- Request - Appeal of Conditions of Approval for Minor Site Plan Review for new building and parking lot
- Location - 726 N Westwood Avenue
- Applicant/Owner - Savannah Marten
Pregnancy Center of Greater Toledo
716 N Westwood Avenue
Toledo, OH 43607
- Architect - Ray Micham
The Collaborative
One Seagate Park, Level 118
Toledo, OH 43604
- Civil Engineer - Dave Kuhn
Feller, Finch & Associates, Inc.
1683 Woodlands Drive
Maumee, OH 43537

The applicant is requesting an Appeal of Conditions of Approval for Minor Site Plan Review for a new building and parking lot at 762 Westwood Avenue. The 1.375 acre site is zoned CO Office Commercial and is currently undeveloped. The project includes the construction of an approximately 14,334 square foot building and associated parking. The applicant also owns the property and building to the south of the subject property. The project will include extending the existing parking lot and shared parking and access drives for the two properties. The proposed building is intended to be used for offices, education/meeting rooms, and a day care.

APPEAL OF CONDITIONS OF APPROVAL
MINOR SITE PLAN REVIEW
TOLEDO CITY PLAN COMMISSION
REF: SPR-14-24
DATE: June 13

SHEET NO.
SP1.00

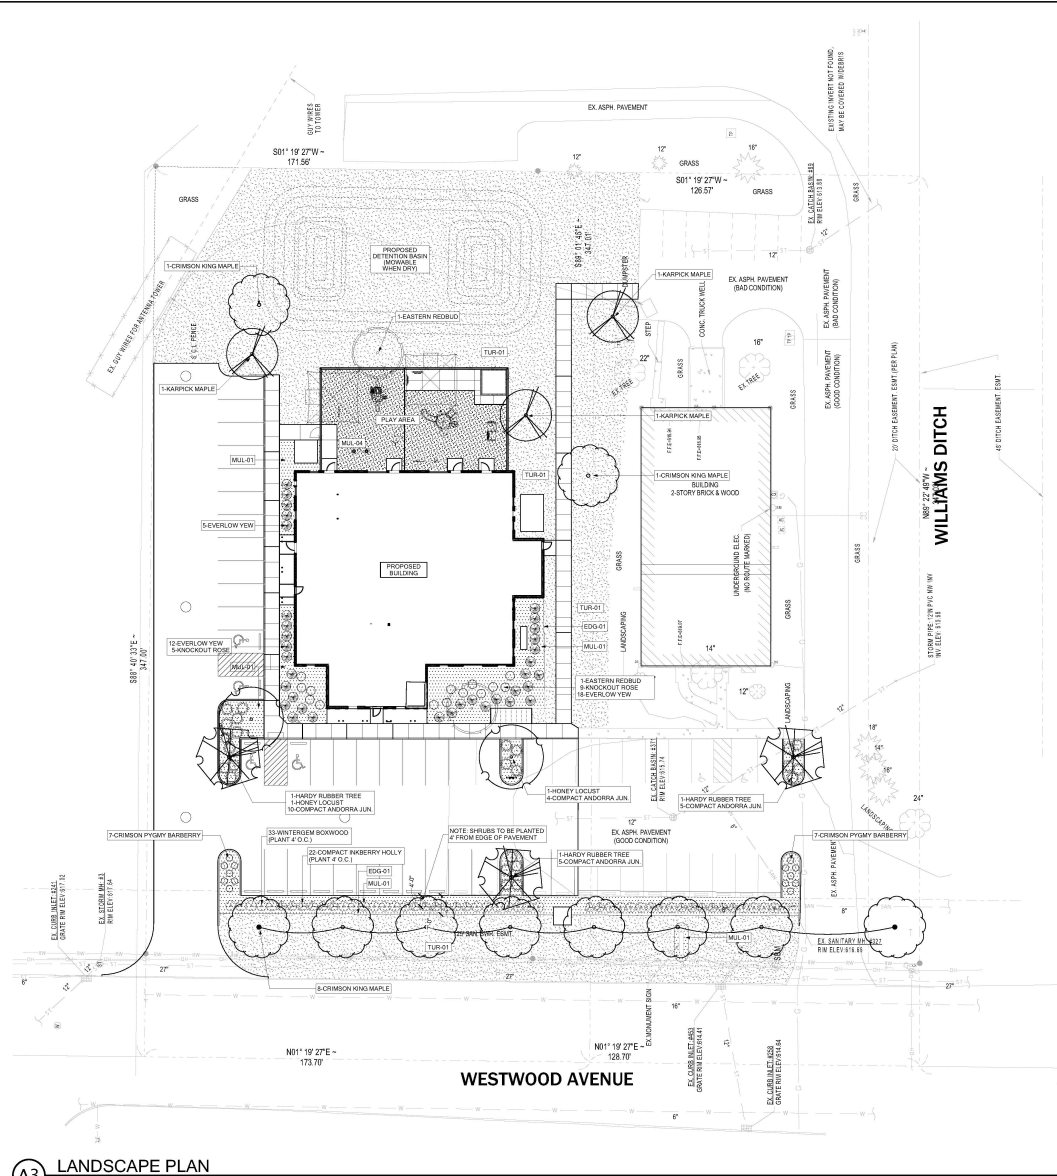
- Condition #24: Maximum front setback for buildings in the CO Office Commercial Zoning District is 35 feet. The proposed building is located 97'1" from the street right-of-way. **Not acceptable as depicted. A BZA waiver shall be secured, or the site redesigned to comply with this requirement.**

33. Per 1109.0204(A) at least one main entrance of any commercial building shall face and open directly onto a 5 foot wide connecting walkway to the street sidewalk without requiring pedestrians to walk around buildings or around parking lot outlines which are not aligned to a logical route. **Not acceptable as depicted. A connecting sidewalk shall be constructed from the sidewalk required by Transportation is Condition #21.**

Take no action on this waiver as the Plan Commission does not have authority to waive setback requirements. The authority to do so is granted to the Board of Zoning Appeals (BZA). The applicant will need to apply to the BZA for relief from this condition. Staff is in support of the waiver as the setback is consistent with the existing development to the south. This will allow the applicant to expand the existing parking lot and share parking and access drives thereby providing safe, efficient and convenient movement of traffic within the site and on adjacent roadways.

E1 WEST EXTERIOR ELEVATION
SCALE: 1/8" = 1'-0"

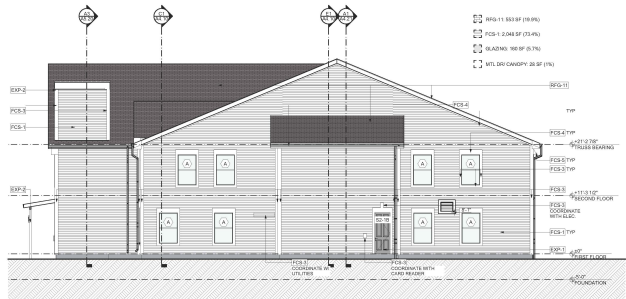
- Condition #34: Per 1109.0205(C.3) transparent windows shall occupy at least 40 percent of the area between two and ten feet at grade from the base of the primary elevation facing the right-of-way. **Not acceptable as depicted. The west elevation, which faces the Westwood right-of-way, will need to be designed to meet this requirement.**

- Condition #35c: The north, south and west elevations of the proposed building are visible from the Westwood Avenue right-of-way. These elevations are required to consist of a minimum of 80 percent of a predominant building material and no more than 20 percent of an accent material. The proposed elevations consist mainly of fiber cement siding, which is considered an accent material. **Not acceptable as submitted. Revised elevations shall be required depicting no more than 20 percent fiber cement siding, or any other accent material.**

34. Per 1109.0205(C.3) transparent windows shall occupy at least 40 percent of the area between two and ten feet at grade from the base of the primary elevation facing the right-of-way. **Not acceptable as depicted. The west elevation, which faces the Westwood right-of-way, will need to be designed to meet this requirement.**

- c. The north, south and west elevations of the proposed building are visible from the Westwood Avenue right-of-way. These elevations are required to consist of a minimum of 80 percent of a predominant building material and no more than 20 percent of an accent material. The proposed elevations consist mainly of fiber cement siding, which is considered an accent material. **Not acceptable as submitted. Revised elevations shall be required depicting no more than 20 percent fiber cement siding, or any other accent material.**

Approve the waiver to reduce the required percentage of transparent windows to ±23 percent because the structure is intended to look like a house, not a commercial storefront and the intended use is a day care.

Approve the waiver to allow the use of fiber cement siding as a predominant material since the surrounding zoning and land uses are predominantly industrial in nature, and the material standards are not applied to industrial zoned properties. In addition, the structure is intended to look like a house and the intended use is a day care.
